Product : CRT monitor	Bulletin No : 02-C/M-E0081
Model : AQ19L,AQ19J*	Bulletin Date : Aug.28,2002
	ECN Date : Aug.28,2002

SUBJECT : Before service to prevent touch PCB pattern and metal guide

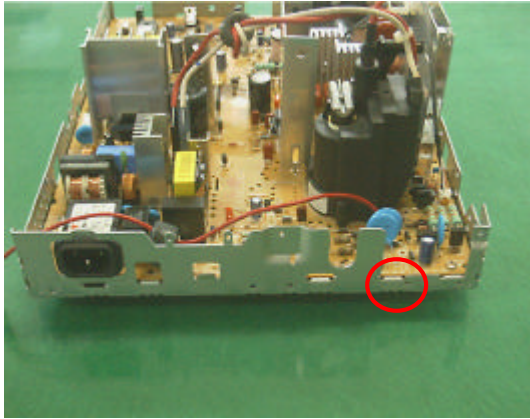
Background : The 540V PCB pattern can touch with metal chassis guide part although pattern covered with protection paint.
 In this case cause some parts failure (R513/R570)
 Problem range : PCB ver MP 1.2 ~ MP 1.4 (Production: Oct.2001 ~ Aug.2002)
Permanent solution : Change PCB pattern from ver 1.4 to ver 1.5 (Sep.2002~)

Solution Do "+1" service for all returned units if its PCB ver is MP1.2 ~ MP1.4.
 Bend metal guide to prevent touch with PCB pattern.
 Refer to additional information for detail work instruction.
